**Subject: Alternative Road Standard Request
Grip Road Gravel Mine Access Road
Mining Special Use Permit PL16-0097
Concrete Nor'west and Miles Sand & Gravel**

TO: Mike Janicki
Dan Cox
FROM: Jordan M. Janicki, PE, SE
DATE: April 13, 2017
RE: Janicki Logging 40ftx14x Bridge Load Rating
Location: Off Grip Road, Sedro-Woolley, WA

SIGNAGE PLAN
STATION 15+00 TO 30+00

To: Paul Randall-Grutter, PE – County Engineer, Skagit County Public Works
From: Matthew Palmer, PE *MP*
Subject: Traffic Study Review
Project: Grip Road Gravel Pit, GTC #17-161
Date: December 18, 2018

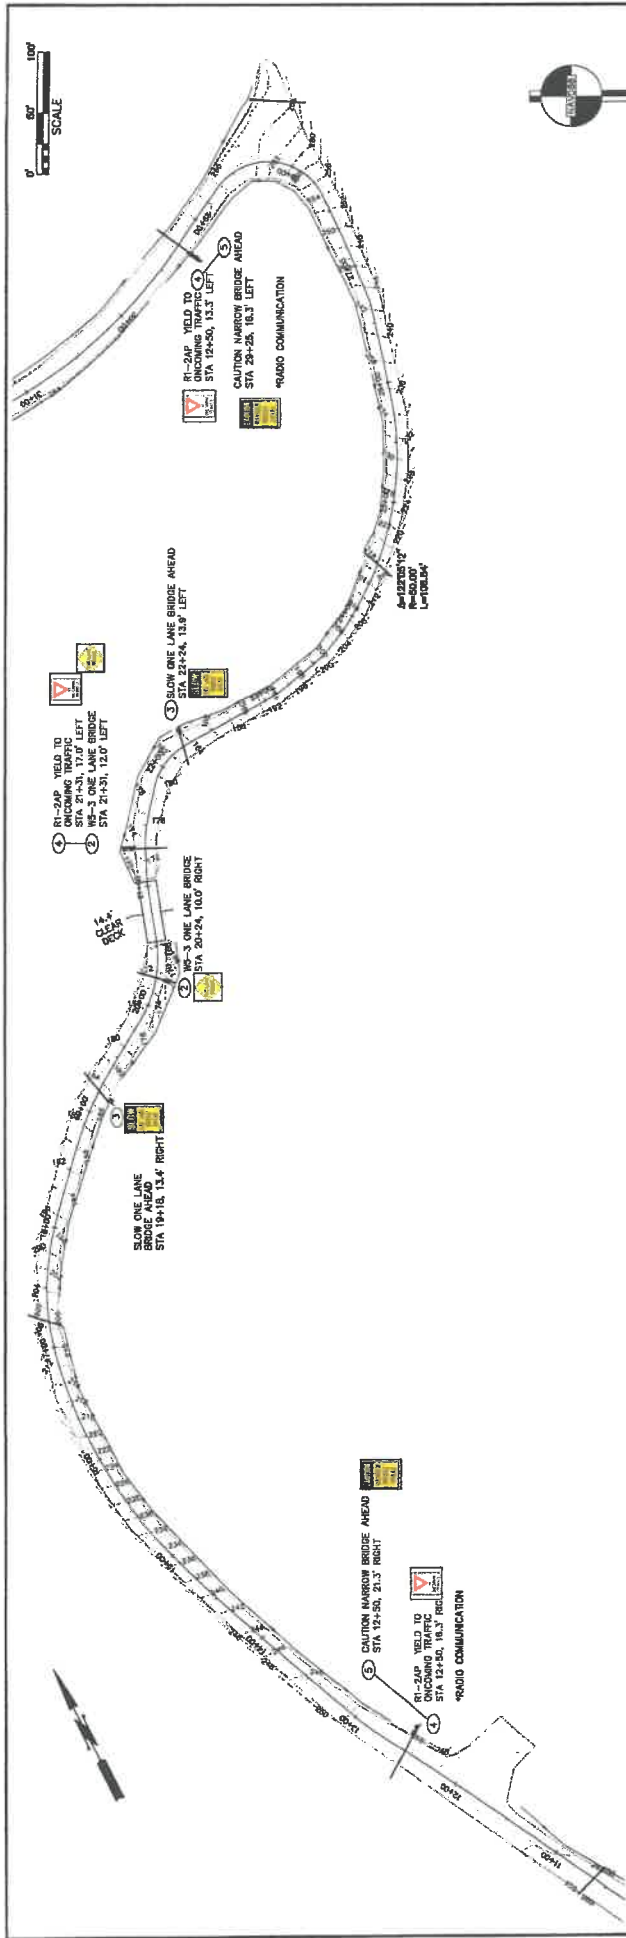
Included for review is the Grip Road Gravel Mine Access Road As-Built drawings (September 13, 2018), both in plan and profile. On Sheet C10 of this plan set is a proposed signage plan intended as an engineered alternative that fully meets the safety, function, appearance, fire protection and maintainability as outlined above for the alternatives and minor deviation to the width, slope and the one-lane bridge.
